Planning Commission Staff Report

Marmalade Lofts

Planned Development PLNSUB2012-00112
Subdivision Preliminary Plat PLNPCM2012-00111

737 North 300 West
Hearing date: June 26, 2012

SHEET TITLE
 ELEVATIONS

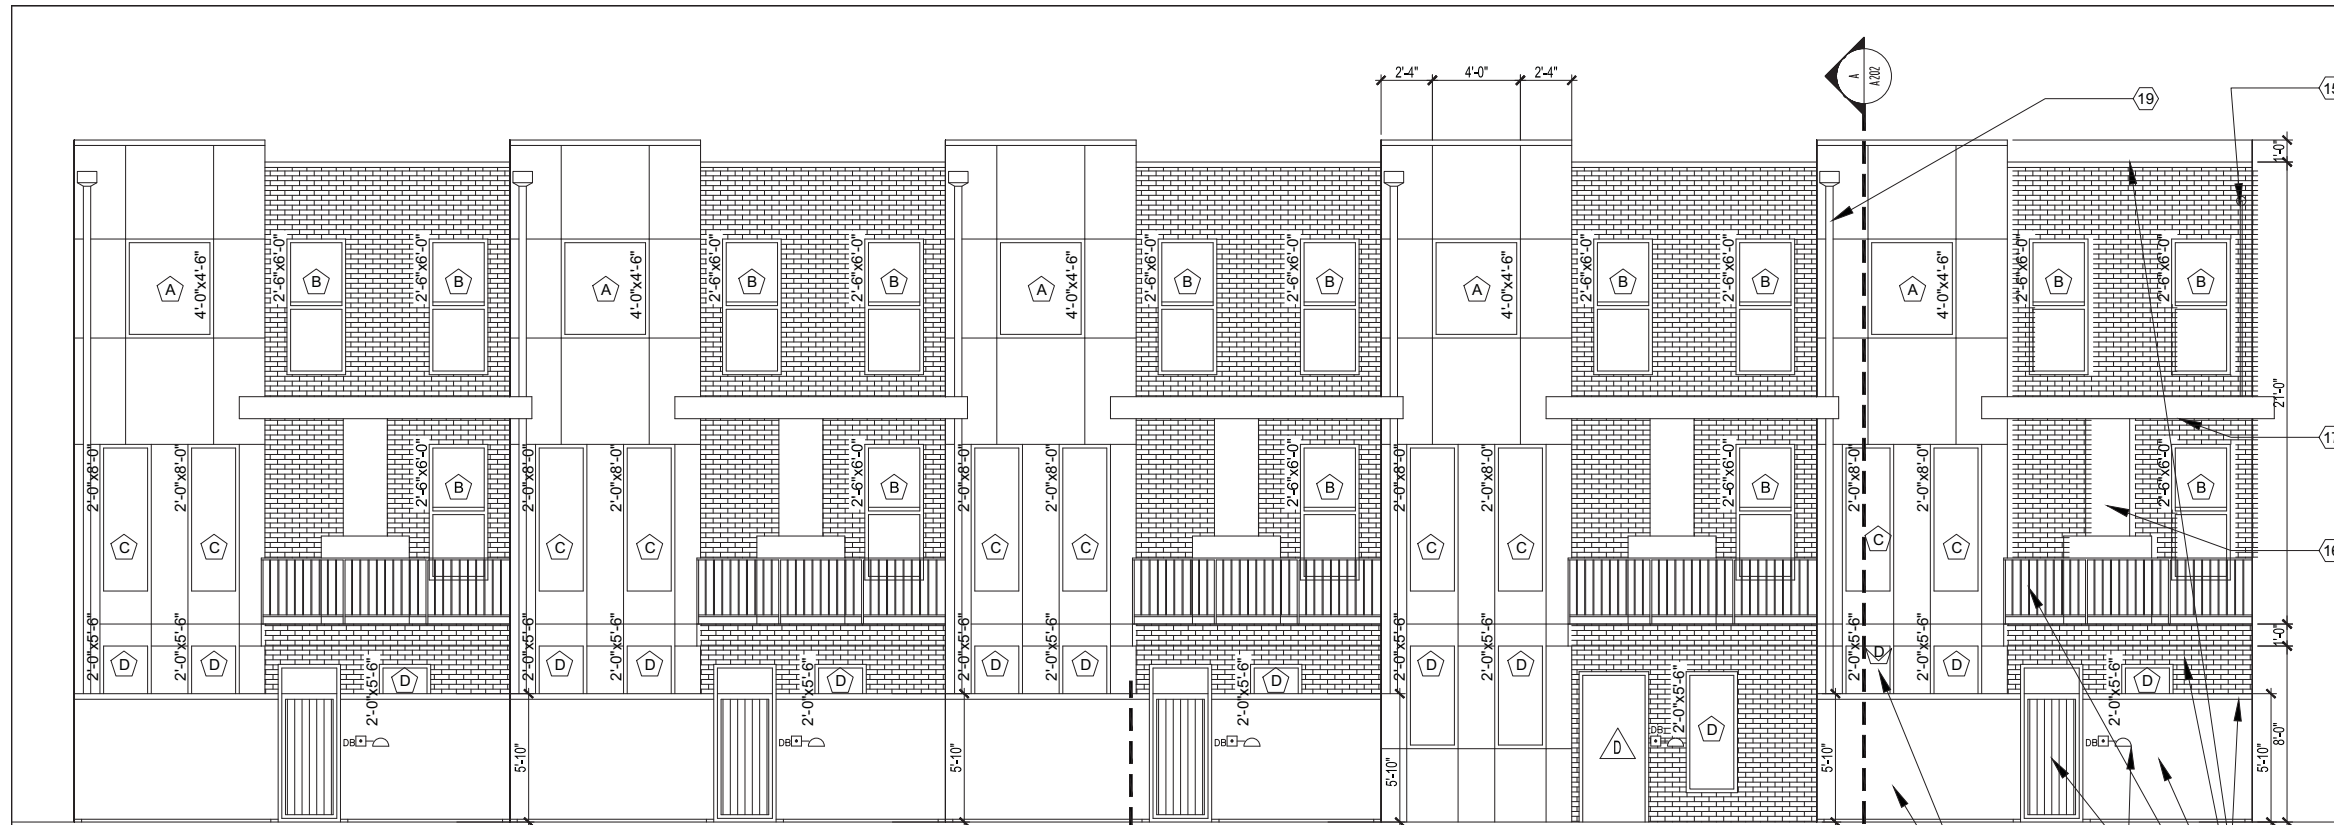
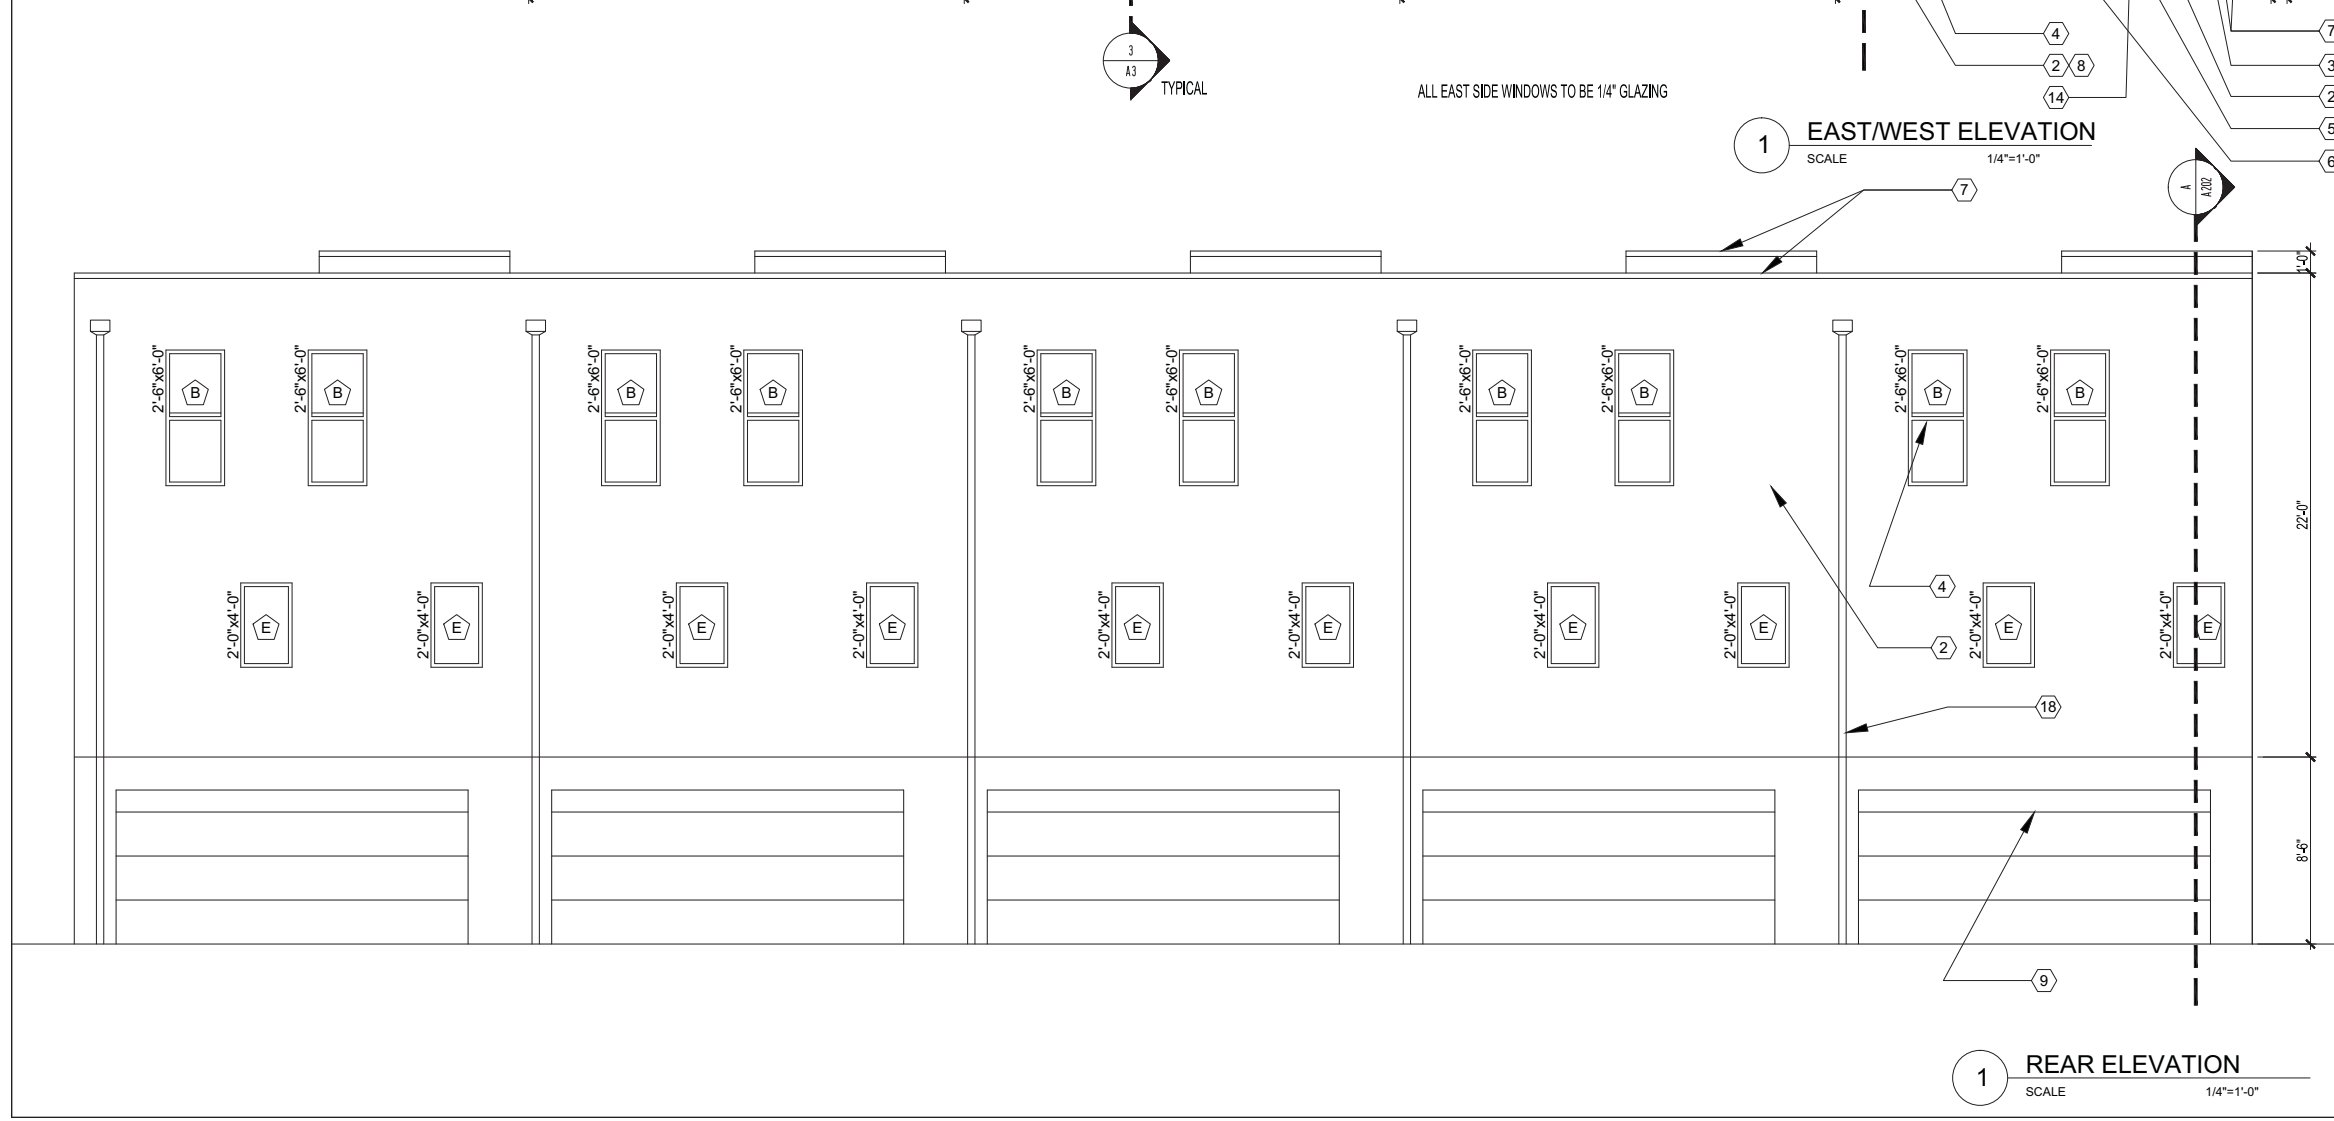
- > Walls and fences in front yard area along 300 West: The proposed masonry walls of the units along 300 West comply with zoning requirements but staff is concerned with their design in relation to this residential development and the visual impact. The walls meet the height and materials standards for walls/fences in “nonresidential” districts. There is no “modification” sought by the applicant for the walls. Despite their compliance with standards, they present a solid visual barrier along the prominent face of this residential development. In planning staff’s opinion, the walls should include more openings, possibly with wrought-iron or other fence materials, at least for that portion directly facing the public way. The sides of the walls might be kept as masonry in order to provide privacy between adjacent units, but the front walls should be more open to avoid a barrier affect. This is reflected in a proposed condition in staff’s recommendation.

- > Building façades: The building facades of the south end of the project, and along Reed Avenue are lacking in visual interest. The applicant has added a few architectural features along Reed Avenue, but staff would prefer to see more since this is a prominent face of the development and a main point of entry. The south façade along the side property line is not as visually prominent, but the façade can still be seen by the public traveling north on 300 West. The applicant should incorporate more building features and windows to break up the façade. Any approval of the planned development should include a condition to improve the design on the north and south facades; staff has provided a condition as part of their recommendation on the first page of this report.

The building architecture provides surface relief and horizontal features on the front façade that break up potential blank walls along 300 West, making that façade visually interesting. The corner side façades facing Reed Avenue have fewer architectural features, are limited in visual appeal, and don't interact with pedestrian traffic. The south facades, although not facing a public way, are still visible from 300 West and present a blank, uninteresting wall to the viewer. The north and south facades, particularly the north façade, should be modified to increase visual interest above what is shown on the drawings. If the planned development is approved, the planning commission should include a condition to improve the design on the north and south facades; staff has provided a condition as part of their recommendation on the first page of this report. The landscaping proposed meets the basic requirements for yard areas and the landscape plan shows are good number of trees and shrubs, which contributes to a pleasing environment. Any approval of the planned development should stipulate that the number of trees should not deviate more than 10% from what is on the proposed landscape plan (this is included as a condition in staff's recommendation).

1. Final planned development site plan approval and final subdivision plat approval are delegated to the Planning Director.
2. Compliance with all City department requirements outlined in the staff report for this project. See *Attachment D* of the staff report for department comments.
3. All sections of the wall along 300 West shall be a minimum of 50% open or replaced with fencing that is at least 50% open as determined by the Planning Director.
4. The north and south facades shall be revised to include more visual interest and less blank wall space as determined by the Planning Director.
5. The number of trees on the site shall not deviate more than 10% from the number of trees shown on the landscape plan. The number of trees in the park strip and for buffering shall comply with at least the minimum required by Chapter 21A.48 of zoning ordinance.
